To: INCITS Technical Committee T10
From: Kevin Butt
Date: April 30, 2007 1:20 pm
Document: T10/06-462r5 — SSC-3: Keyless Copy

3. Proposal

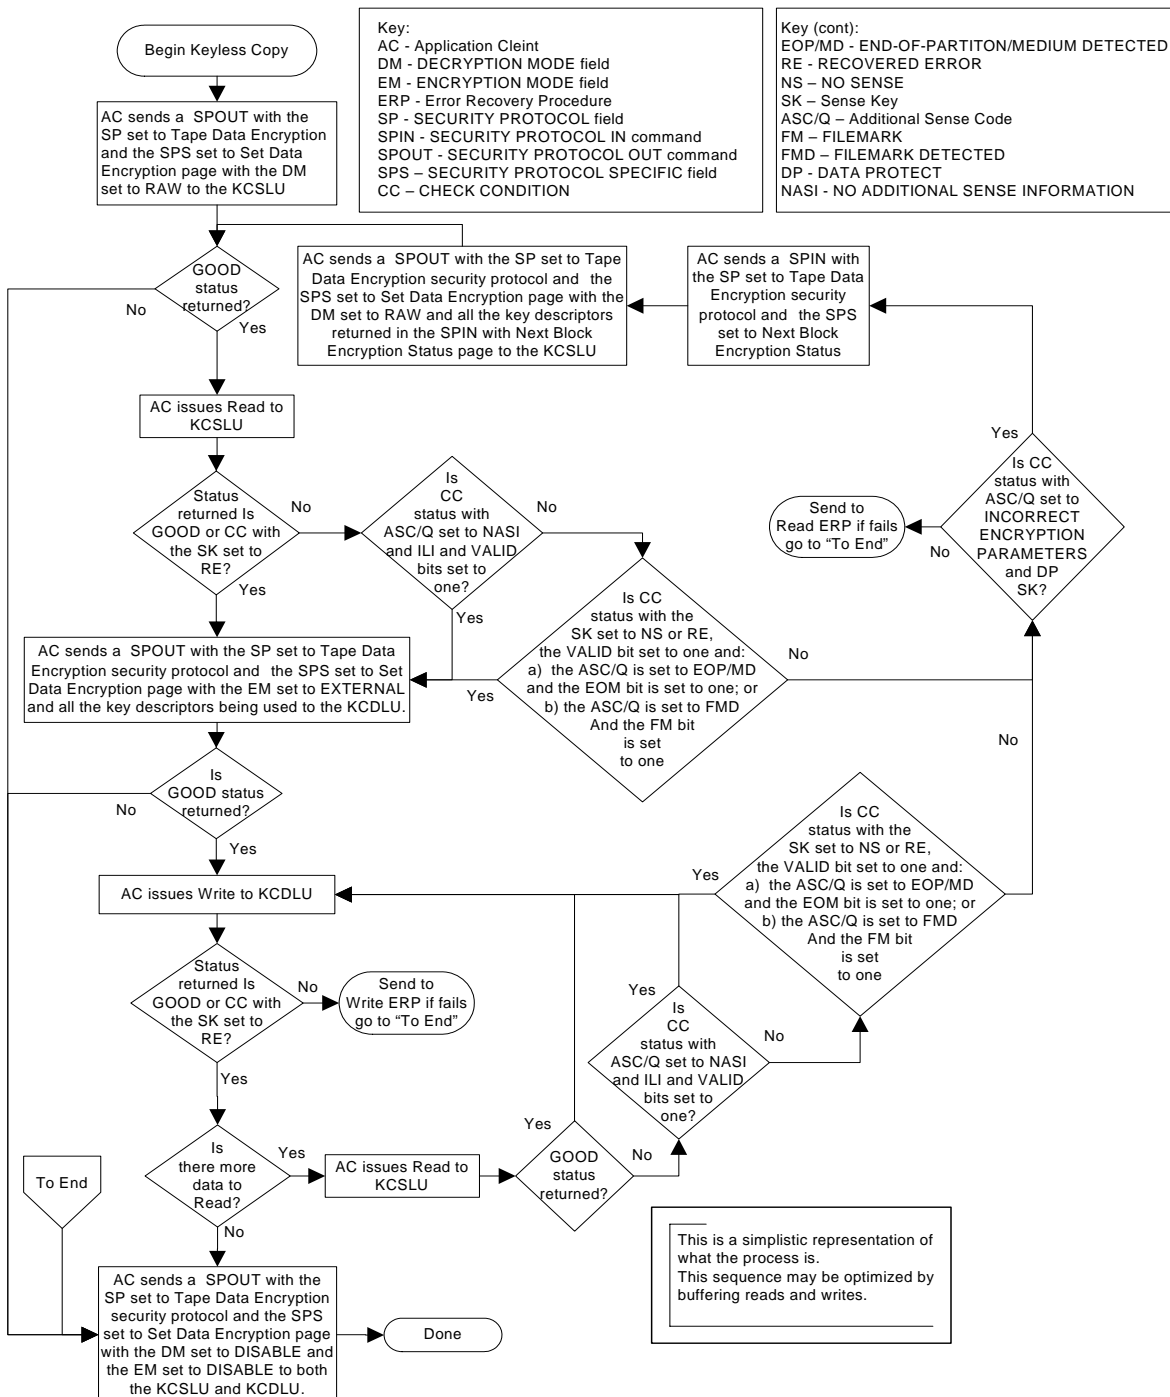
8. 06-462r5 Modified the figure to describe an example of how an application client might implement a keyless copy, listed where to return to the flowchart for ILI and FM Check Conditions.

To accomplish a keyless copy operation an application client sets the KCSLU decryption mode to RAW and the KCDLU encryption mode to EXTERNAL. It then reads one or more logical objects from the KCSLU and writes those logical objects to the KCDLU. During this process if the KCSLU detects a mismatch between the key-associated data in the data encryption parameters and the key-associated data on the medium during a read operation, the KCSLU returns a CHECK CONDITION status to the application client to notify it that some action is required. An example of this is shown in the informative flowchart in figure xx.
